Monday, 18/08/2008 10:26:57 AM Julie Lecocq **Process Sheet** : CU-DAR001 Dart Helicopters Services : ARM Customer **Drawing Name** Job Number : 41288 **Estimate Number** : 12884 : D3560044 P.O. Number Part Number : D3560 REV D This Issue : 18/08/2008 S.O. No. : **Drawing Number** Prsht Rev. : NC : N/A Project Number First Issue : // Type : MACHINED PARTS **Drawing Revision** .: D : 36421 Material Previous Run Qty: Each **Due Date** : 10/09/2008 Written By Checked & Approved By Comment : Est Rev:A EC Est Rev B EC verified by DD ECN 987 07.10.09 Est Rev:C ECN1048 DD veriffied by: EC 07-12-18 Additional Product Job Number: Seq. #: Machine Or Operation: Description: 1.0 M6061T6B0500X05000 6061-T6 Bar .500 x 5.00 Comment: Qtv.: 1.3598 f(s)/Unit Total: 13.5975 f(s) 6061-T6 Bar 0.50" x 5.00" M108854X4 Batch: M109025X6 BAND SAW BAND SAW 2.0 Comment: BAND SAW Cut blanks 15.500" long 3.0 HAAS1 HAAS CNC VERTICAL MACHINING #1 Comment: HAAS CNC VERTICAL MACHINING #1 1- Mill as per Folio FA696 Rev: AA & Dwg D3560 Rev: 2-C'sink 0.196" hole on manual mill as per dwg D3560 3-Deburr per dwg D3560 4.0 QC2 INSPECT PARTS AS THEY COME OFF MACHINE Comment: INSPECT PARTS AS THEY COME OFF MACHINE

DART AE

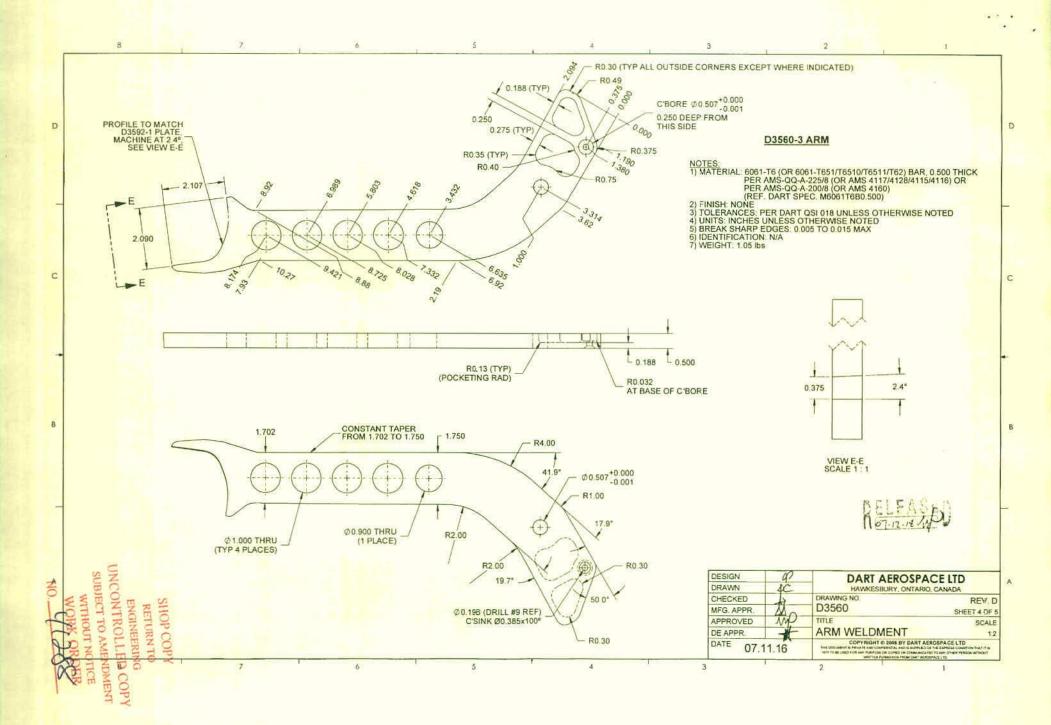
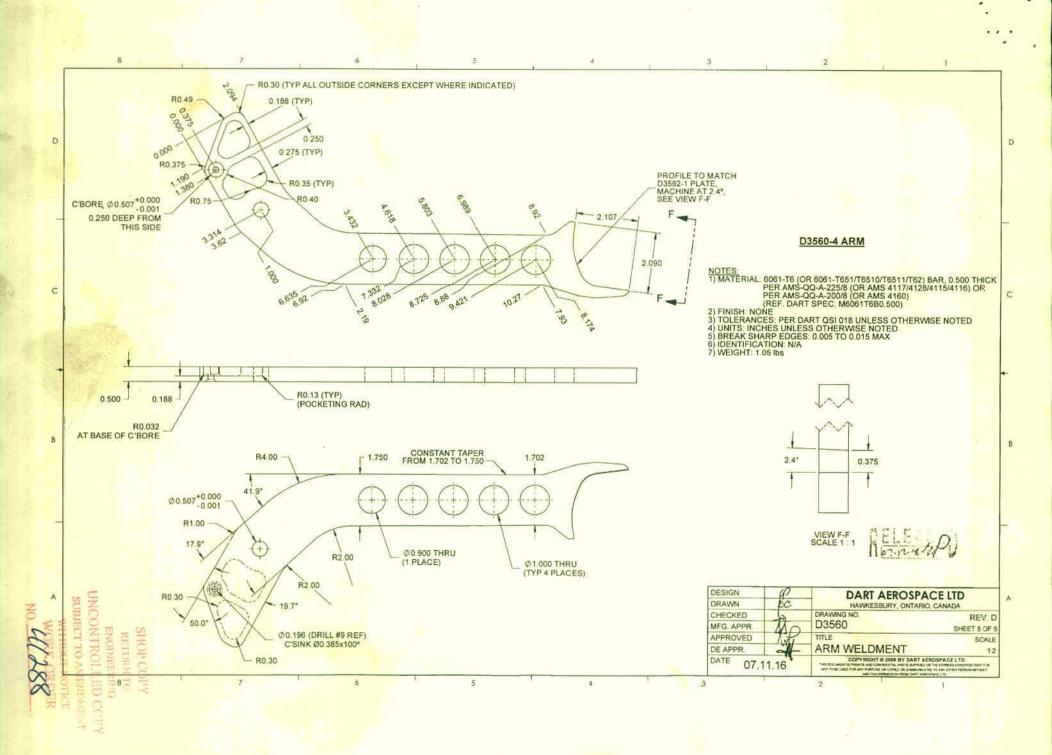
We have 13x D3560-044 and 1x D3560-042 that have cracks all but 1 in the same location. Attached image D3560-044 Crack 1 shows where 13 of the 14 cracks occurred. D3560-044 Crack 2 shows where the other crack occurred. The cracks shown in D3560-044 Crack 1 vary in depth from roughly 3/32 to ½ inch. I discussed this with Chris and Peter the consensus opinion is the parts are scarp. Further discussion with Chris indicates that changing grain direction to 45 degree on the sheet metal part may lower the scrap rate but not eliminate it. This has been done on a previous deviation with a less scrap. D3560-044 Crack 2 appears to just be an anomaly.

I am not comfortable with any sort of repair to these parts.

I think that all 14 parts should be scrapped.

And, at the risk of stating the obvious, we need to revisit the manufacturing process of this joint.

My preference, as it was a couple of years ago, is to eliminate this weld.

However, the geometry in that area is a little tricky. Suggest we generate an NCR or PAR or whatever.
